Product Change Notice (PCN)

PCN Number: PCN-0450265R-01

Product(s) Affected: SDS-J series (SDS-40J, SDS-50J, SDS-60J, SDS-70J, SDS-80J, SDD-130J)

Reason(s) for Change: Manufacturing build location change.

SDS-40J

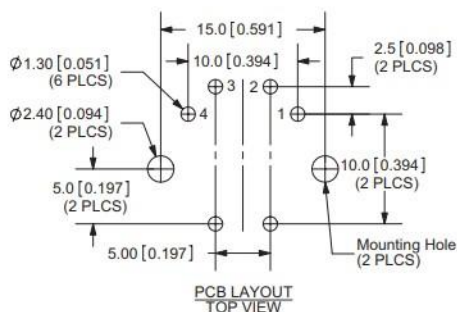
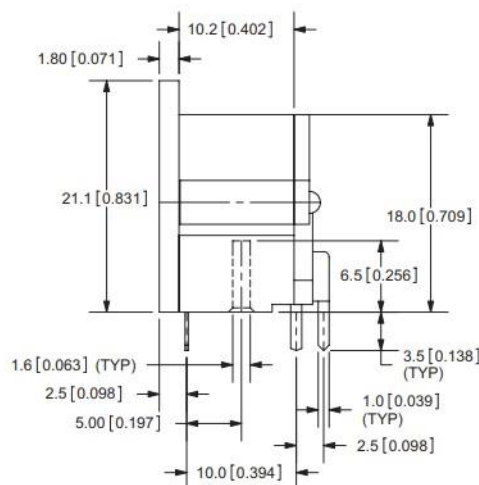
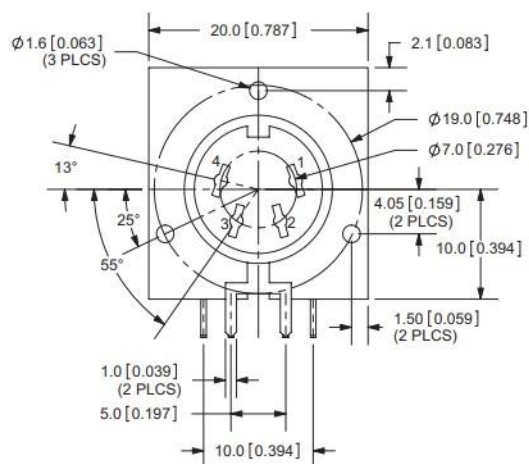
Description of Change: Dimensional changes and materials changes as shown below.
